DESIGN ADVISORY BOARD Tuesday November 22, 2016 at 3:00 PM Conference Room 12, City Hall, Burlington, VT Agenda

- 1. 17-0581SP; 311-375 North Ave (RM-W, Ward 4N) Eric Farrell**
Sketch plan review of planned unit development with mixed commercial and residential uses, related buildings, and infrastructure.
(Project Manager, Scott Gustin)

MEMORANDUM

To: The Design Advisory Board
From: Mary O'Neil, AICP, Principal Planner
RE: ZP17-0581SP, 311-375 North Avenue
Date: November 22, 2016

SD-7

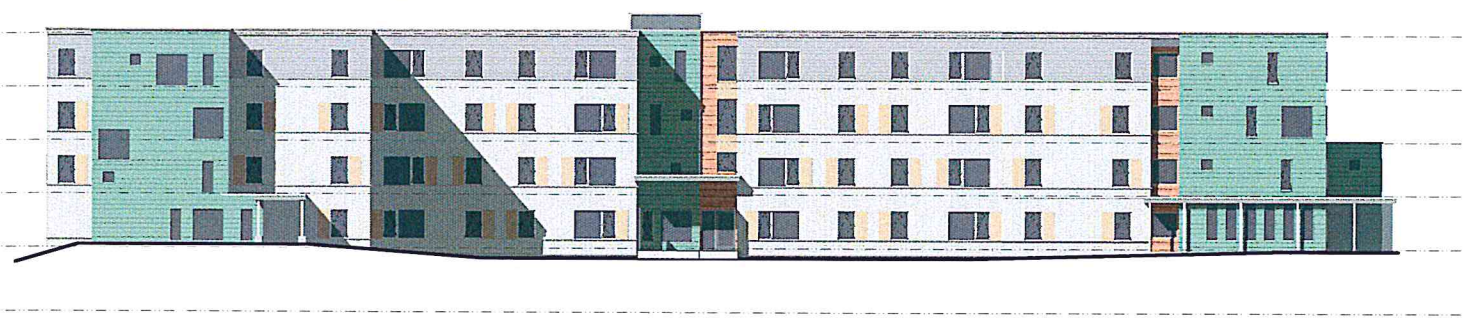
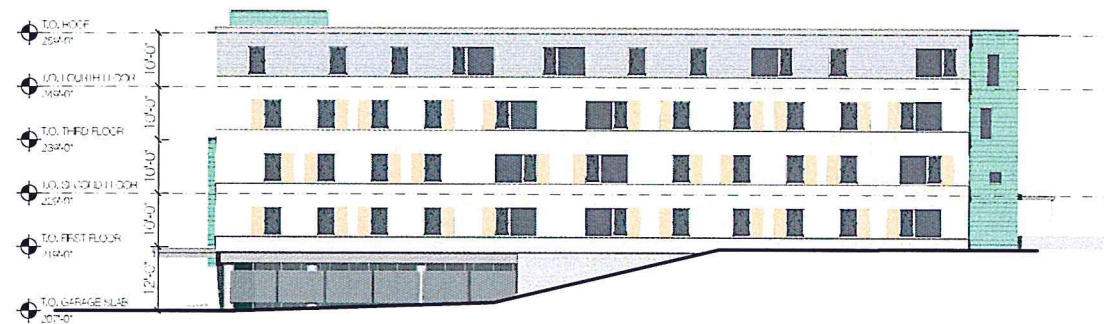
Building K fronts North Avenue and South Road; entrances are visible under extended canopies as well. Building L (SD-7) has visible entries on the north, east and west elevations.

O&P-3

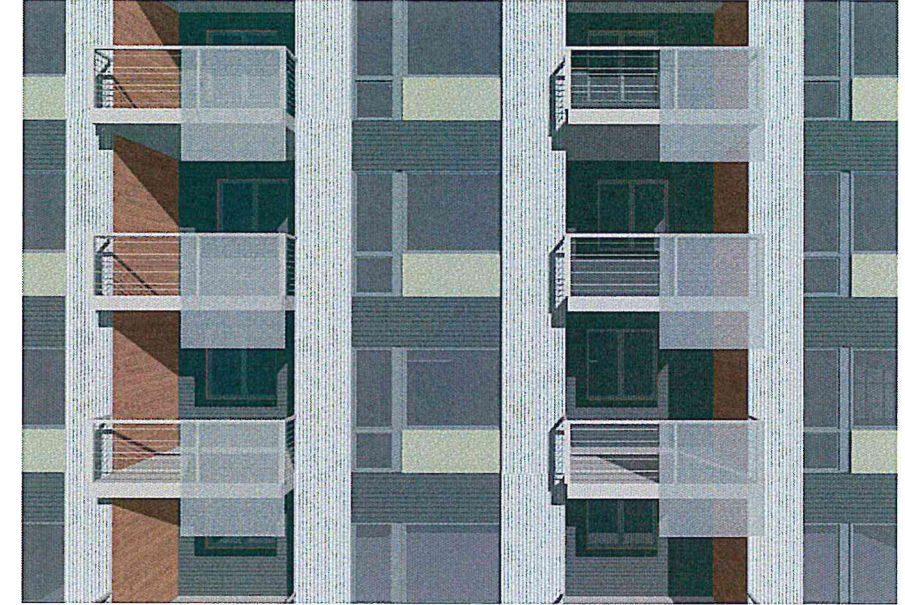
Buildings O and P have a centrally identifiable pedestrian entrance (Plan O & P3), two wing entrances and apparent first floor entries from West Street.

PR-1

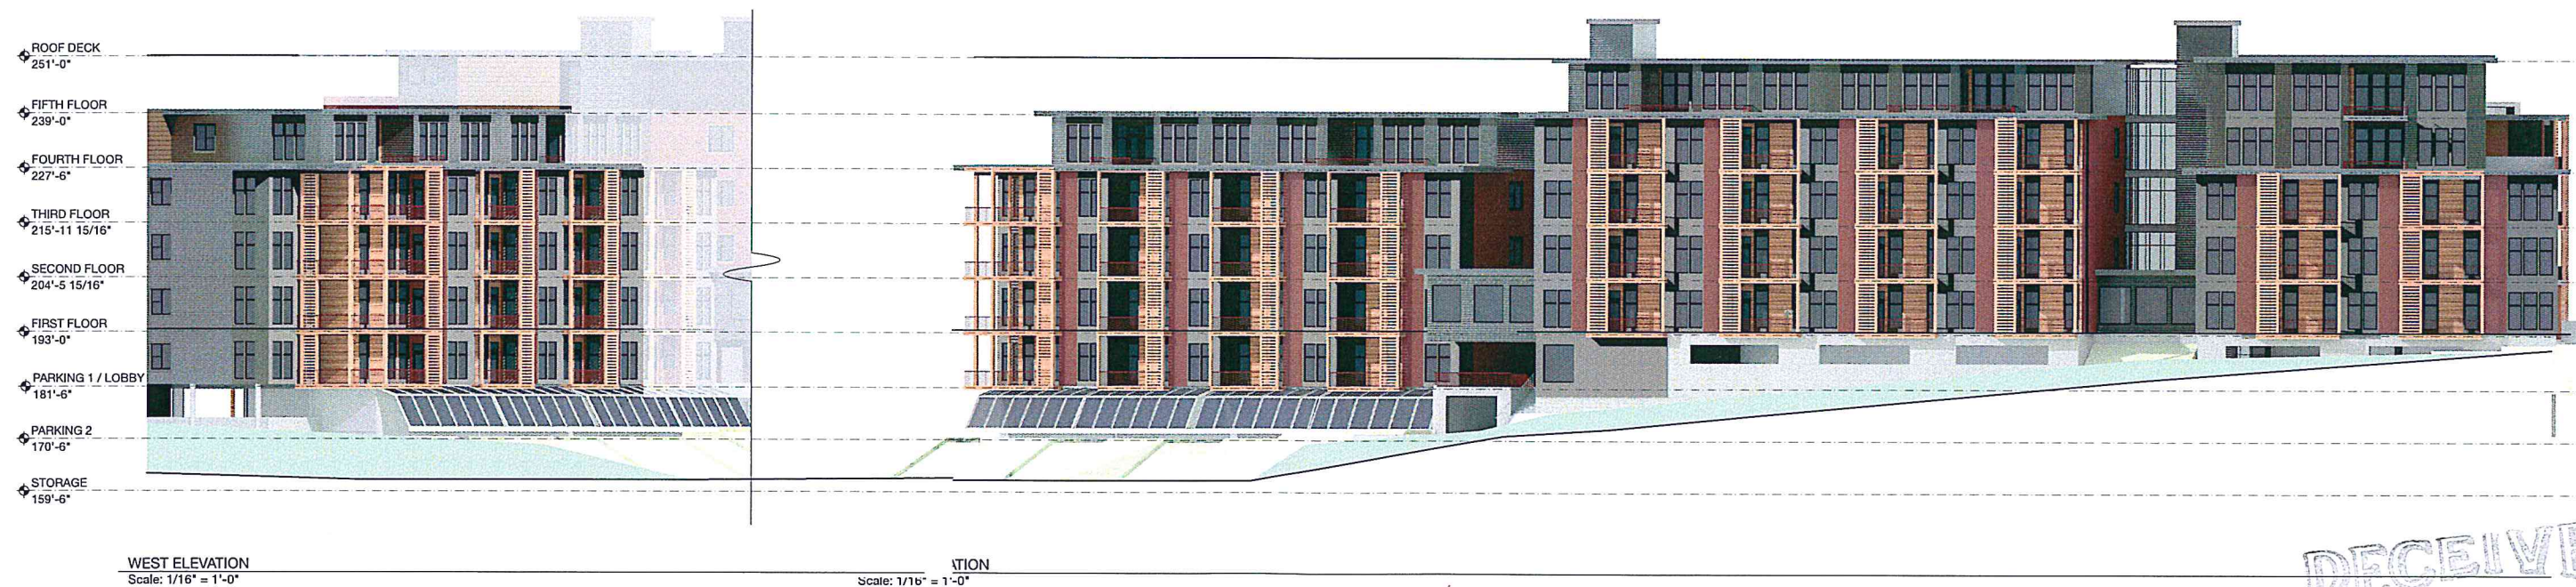
Building Q has a visible pedestrian entry on the east. Views on plan 3 appear to be mislabeled. The complexity of the building treatment and curved nature of the design make other identification challenging.
